Radiation Safety Engineering Assessment Report for the Rapiscan Secure 1000 in Single Pose Configuration

VERSION 2.0

NSTD-09-1085

August 2010

Figure 8-4. Filtered Exposure Readings and HVL

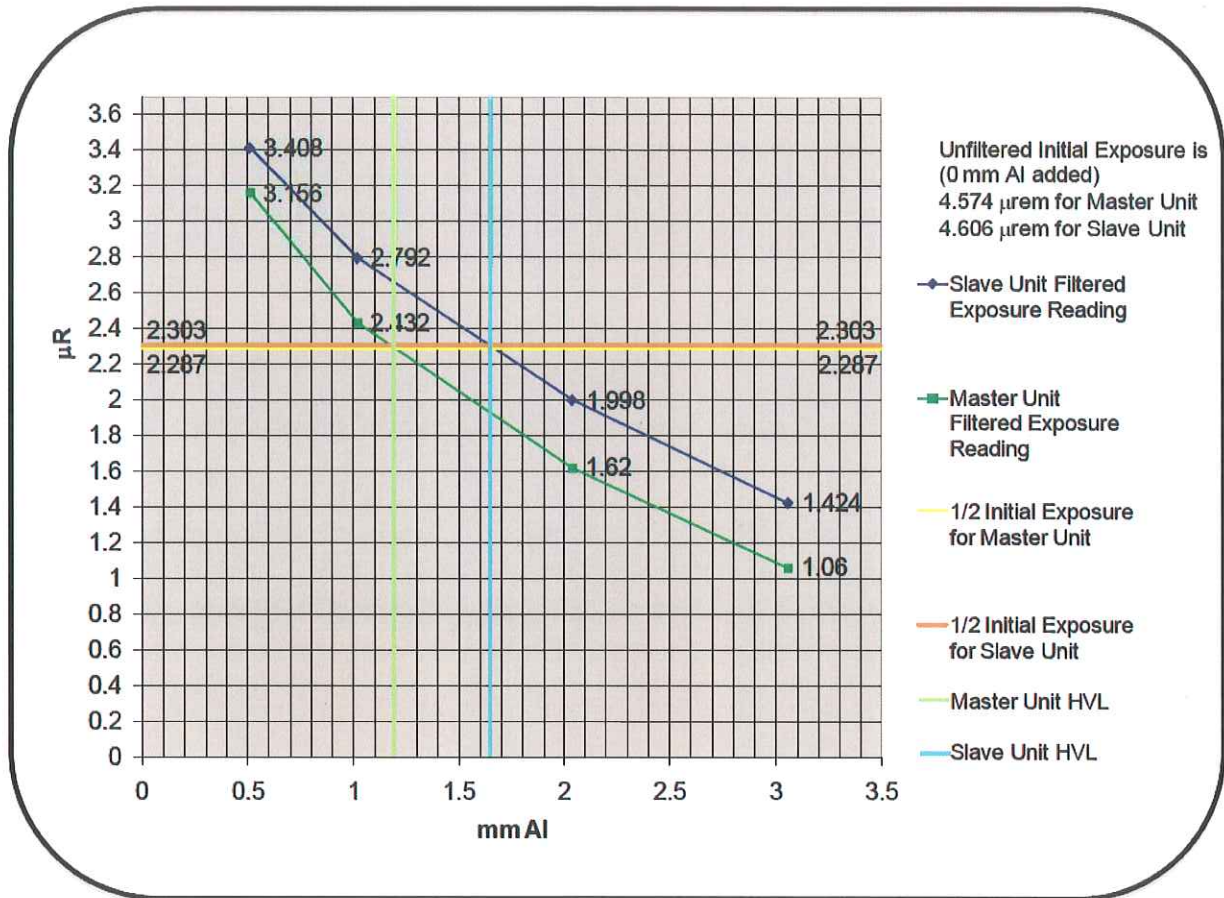
| Section | Change |
|---|---|
| Section 8.3, Figure 8-4 | As a result of a typographical error, the following text in the legend was changed in Figure 8-4: "4.71" changed to "4.574" μrem for Master Unit "4.68" changed to "4.606" μrem for Slave Unit |

Figure 8-11. Dose to General Public Above Units

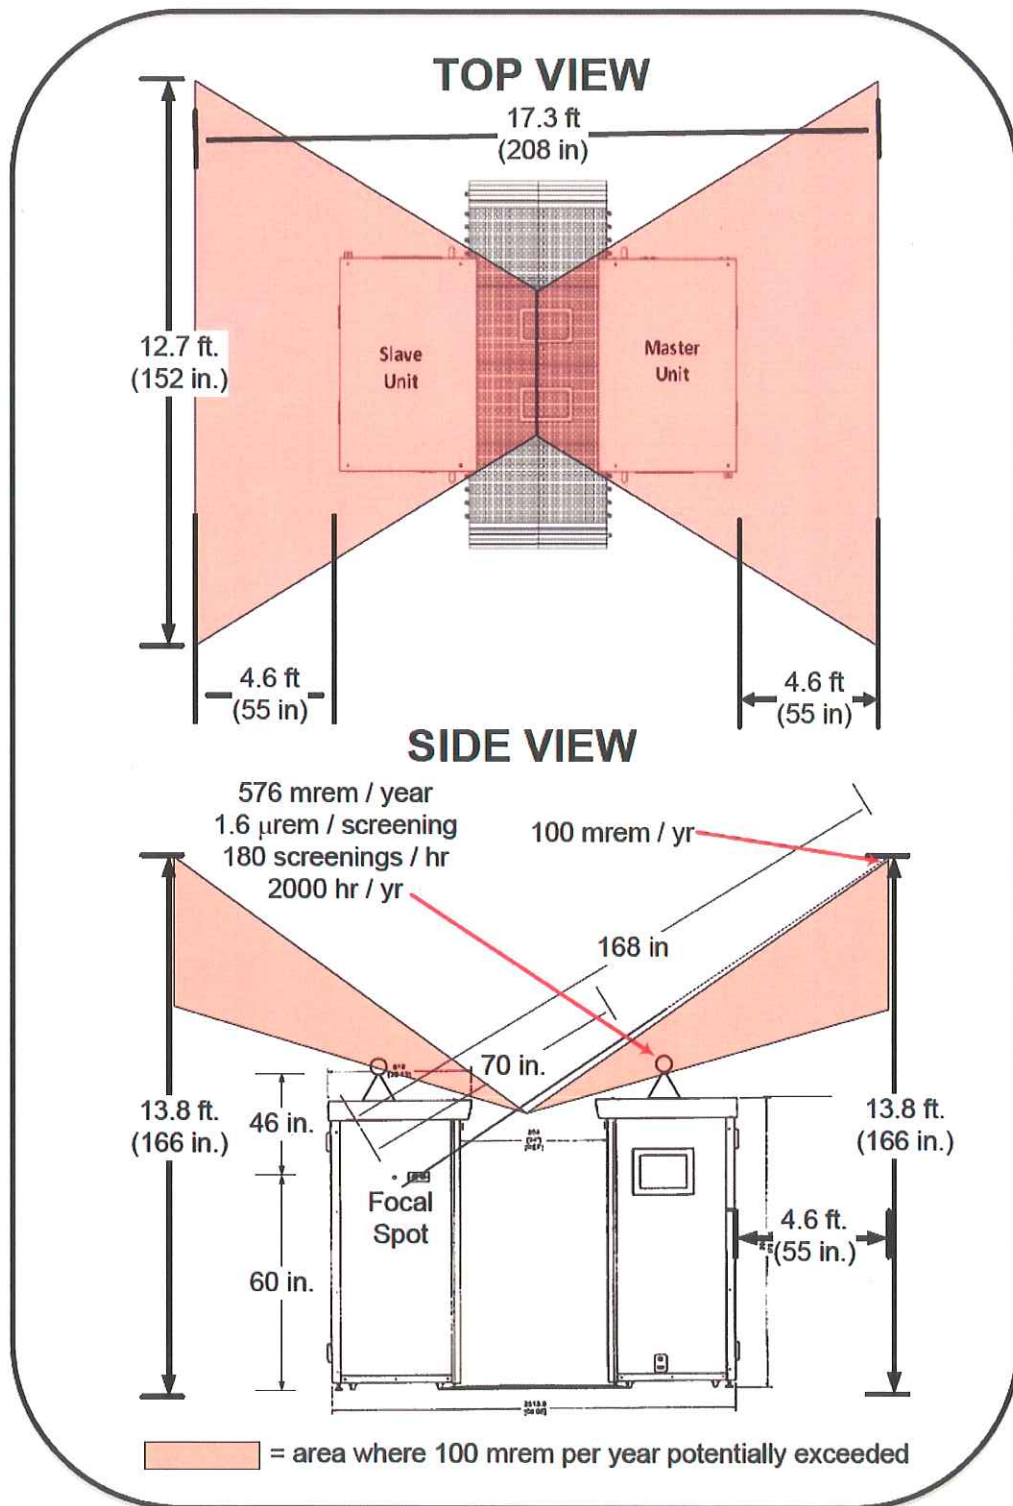
- An area exists above each of the units, due to primary beam overshoot, where the 100 mrem per year general public dose limit could potentially be exceeded. This area extends up to a height of about 14 ft and 4.6 ft behind each of the units.

- For the area above the units, a beam stop may be considered to ensure the general public dose is maintained.
- The dose to bystanders is within the requirements of ANSI/HPS N43.17-2002, 5.4 and ANSI/HPS N43.17-2009, 6.2:

Figure 8-12. Dose to General Public at Entry and Exit Locations

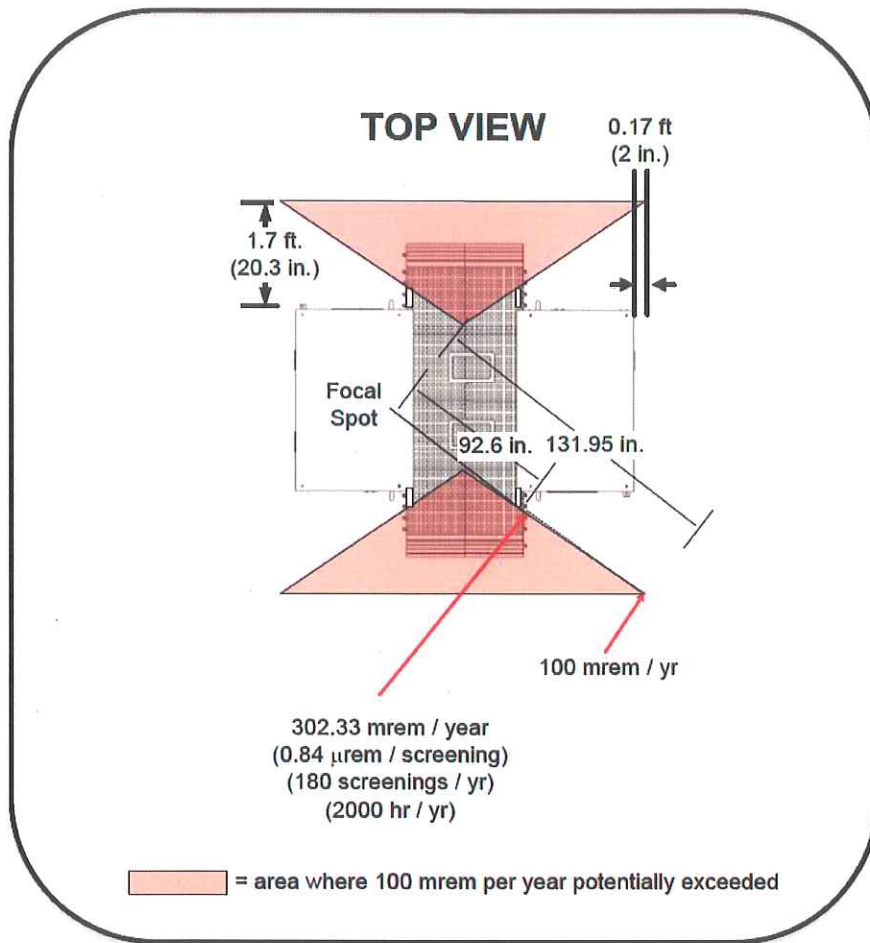
- A second area exists at the entry and exit locations of the scan area, where the 100 mrem per year general public dose limit could potentially be exceeded. This area extends approximately 1.7 ft from the side of the units at the entry and exit locations.

Figure 8-24: Secure 1000 in Single Pose Configuration Label

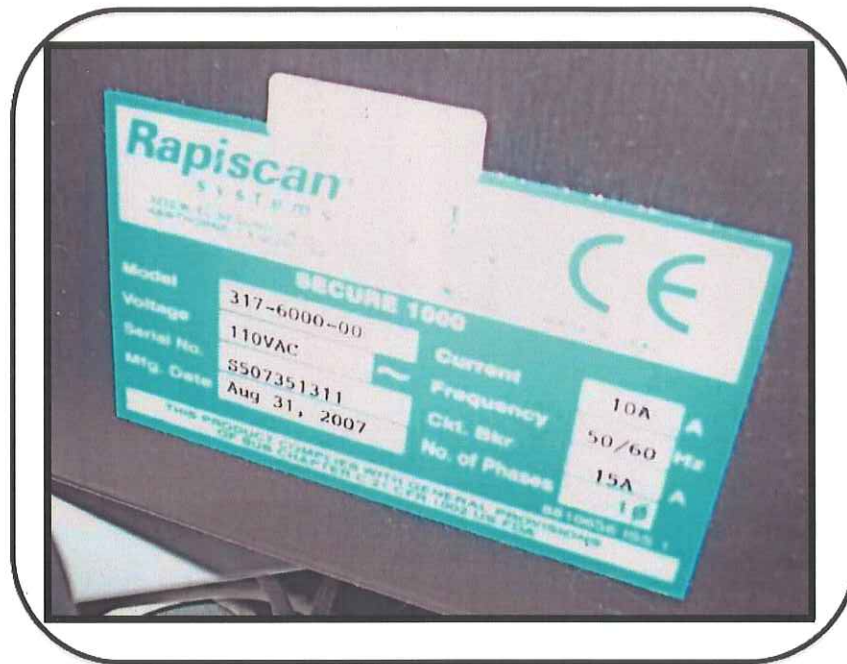
The master and slave unit each have a label that is permanently affixed to the system that includes the name and address of the manufacturer, manufacture date, model number, and serial number (see Figure 8-24). Since an engineering unit was evaluated, the serial number on the label was incorrect.
